IN THE DRAWINGS:

The Applicant respectfully requests that the Examiner approve the changes to Figs. 1, 2, 10, 14 and 18 as indicated in red ink on the enclosed four (4) sheets of drawings. The proposed changes are in response to the Examiner's objections as indicated in the Office Action dated June 24, 2002.

Marked Up Version of Amended Claim 8

Marked up Version of Amended Specification

FIG.1

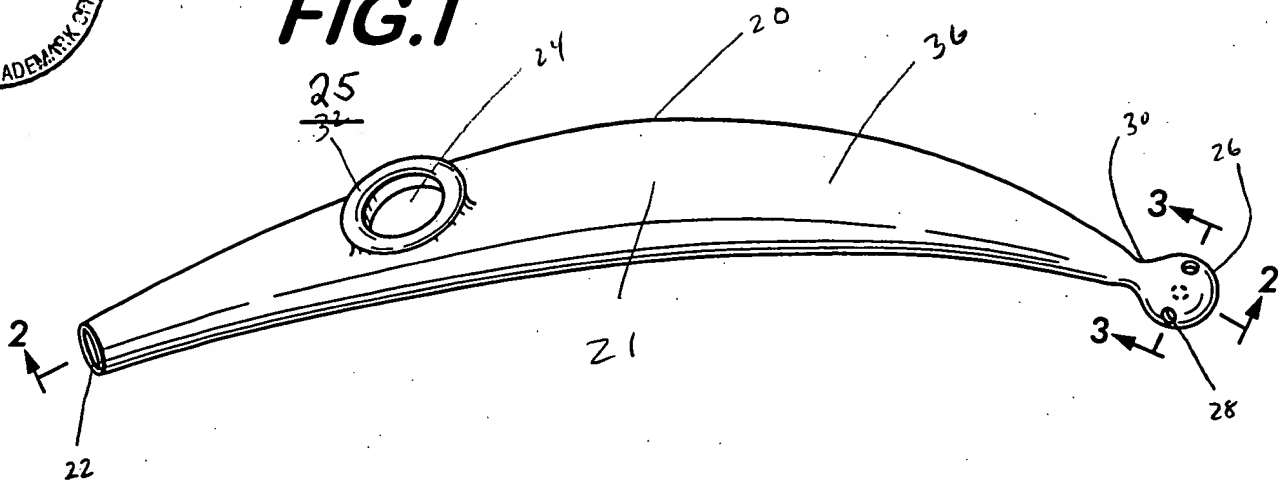
The Examiner objected to Fig. 1 because element 32 is designated in Fig. 1 but is not mentioned in the Specification. In Fig. 1, element 32 includes a lead line pointing to a raised ring. In the Specification at page 10, line 3, this raised ring is designated as element 25. Thus, the drawing has been modified by replacing the designation 32 with the designation 25 to agree with the Specification.

FIG.2

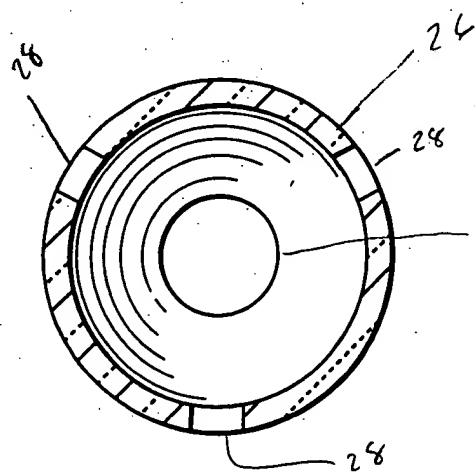
Next, the Examiner objected to Fig. 2 because element 18 designated therein has no support in the Specification. Upon close inspection, it is apparent that the element referred to by the

Examiner in Fig. 2 as "18", in fact, is a less than perfect rendition of a 28 corresponding to the vent hole. This designation in Fig. 2 has been modified to clearly show this element as a 28, not an 18.

FIG.10

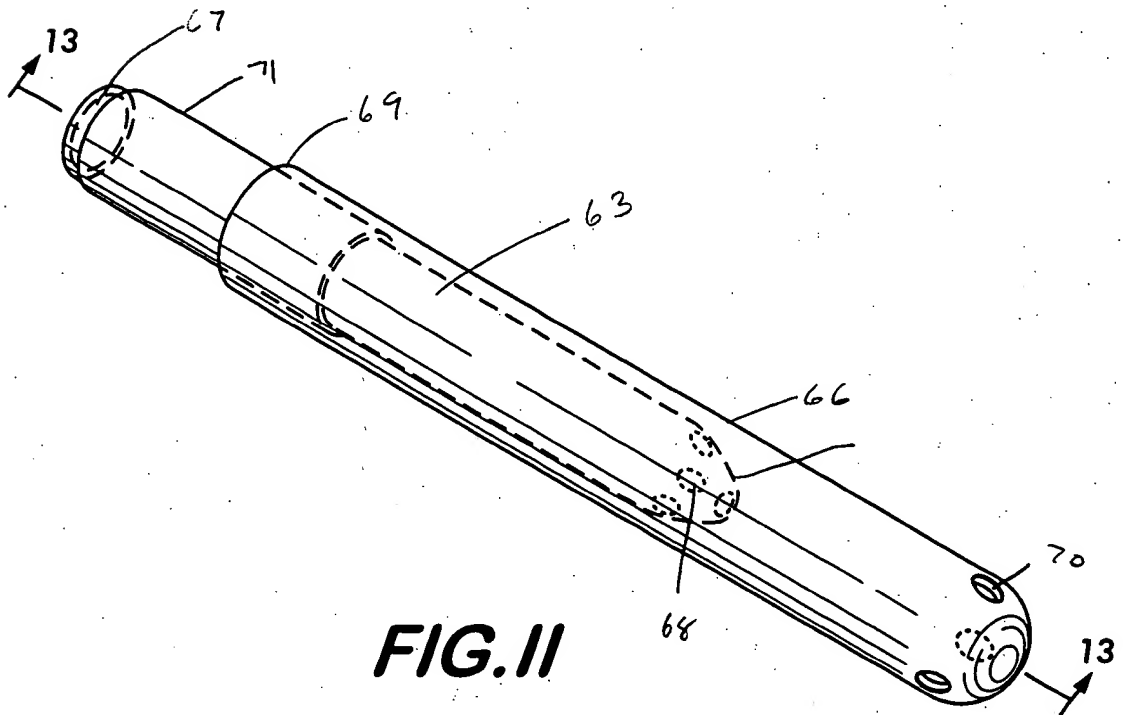
Finally, the Examiner objected to the drawings on the basis that element 57 in Fig. 10 designates different structure than described in the Specification, page 13 line 22 to page 14 line 1. In Fig. 10, element 57 is actually indicated twice. One of the designations 57 has been corrected to indicate element 53, i.e., the second hollow member.

FIG.14

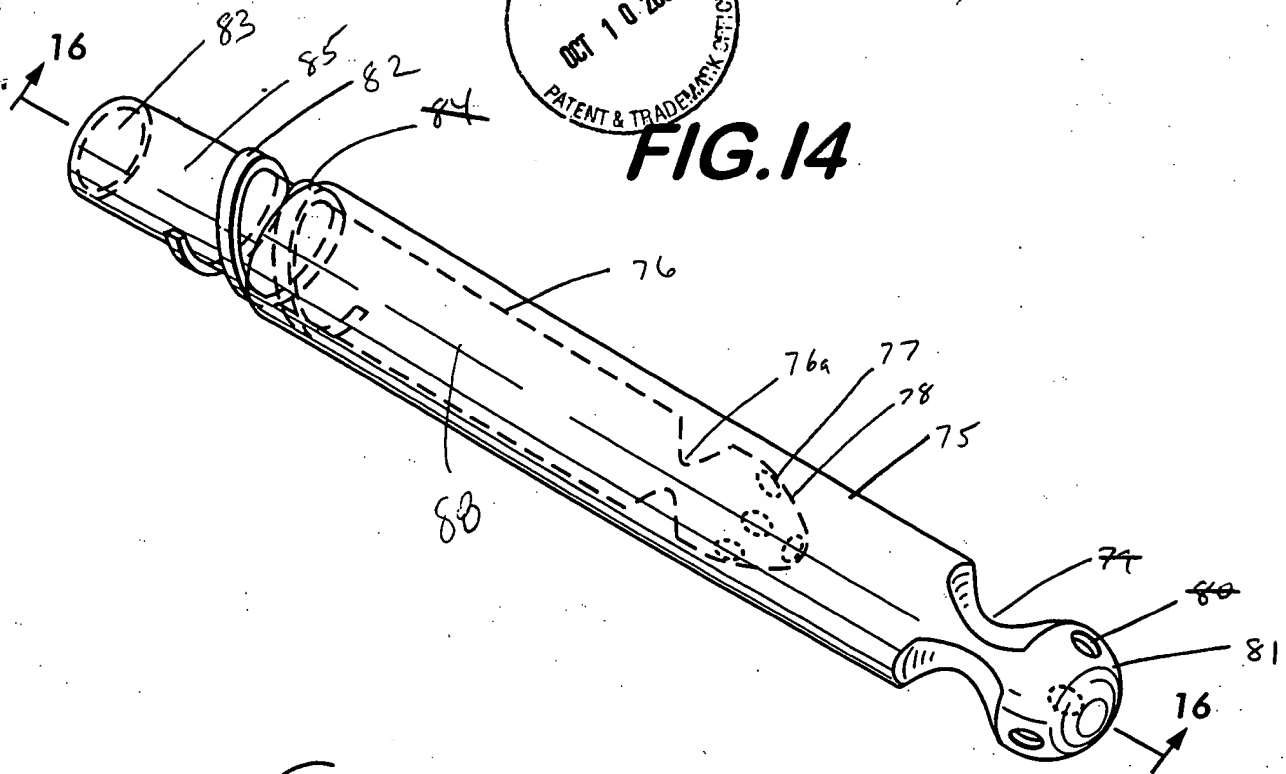
Next, the Examiner objected to Fig. 14 on the basis that elements 79, 80, and 84 designated in this figure are not referred to in the Specification. These reference numbers have been removed from this figure to overcome this objection.

FIG.18

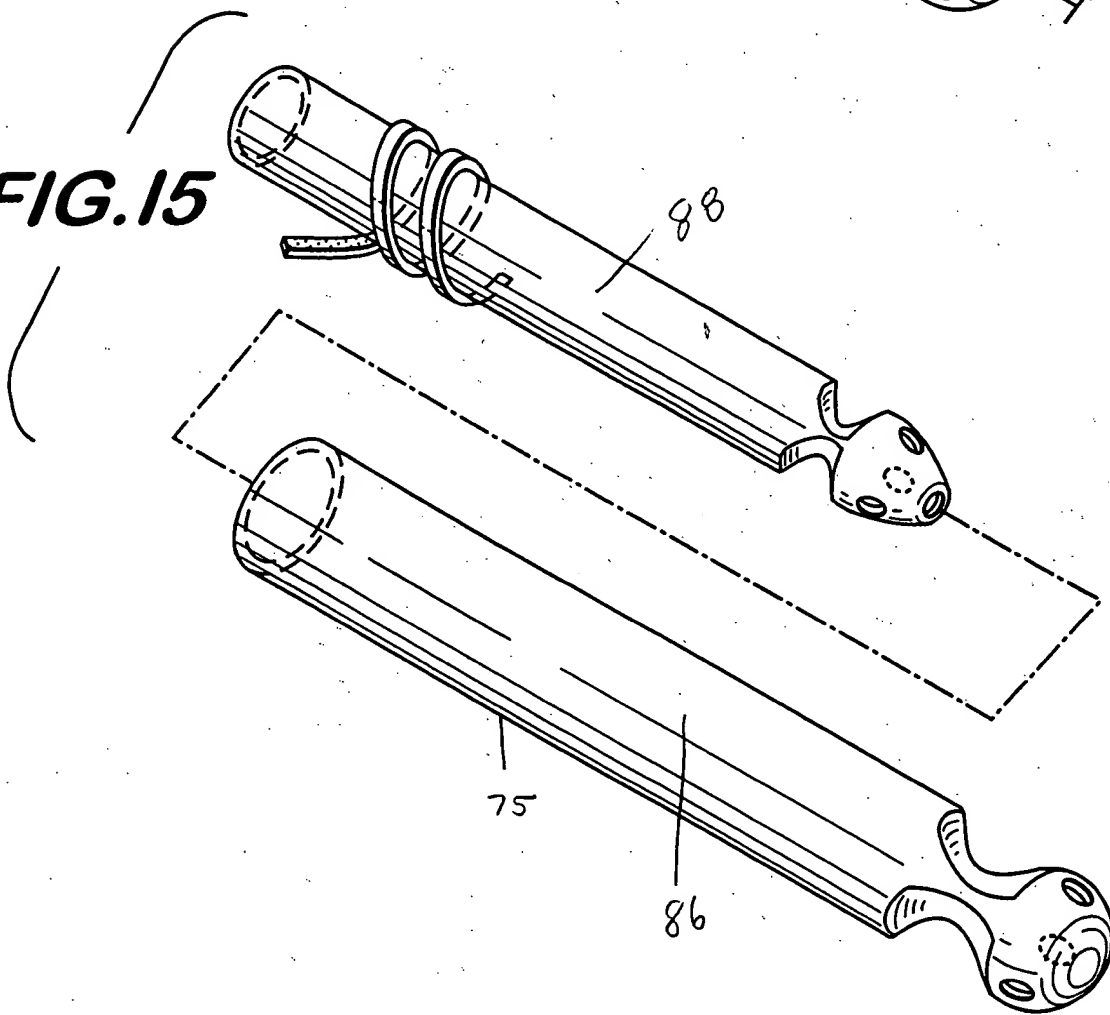
The Examiner has objected to the drawings on the basis that element 108 has been used in Figs. 18 and 19 to designate different structures. In Fig. 19, element 108 designates smoking materials. This designation is supported in the Specification in several places including page 19, lines 2 and 4. In Fig. 18, element 108 designates the adhesive layer on the inner surface of the retention bearing 104. This designation is supported in the Specification on page 18, line 11. Fig. 18 has been modified to replace the designation 108 with the designation 121. Likewise, at page 18, line 11, the Specification has been amended to indicate that element 121 refers to the adhesive layer on the inner surface of the retention bearing. In this manner, element 108 designates only one structure, i.e., smoking materials, and element 121 designates only one structure, i.e., the adhesive layer.

The third hollow member 94 has a narrow strip retention bearing 104 exposed around its proximal end. The inner surface [108] 121 of the retention bearing also includes an adhesive material to be affixed to the third hollow member 94.
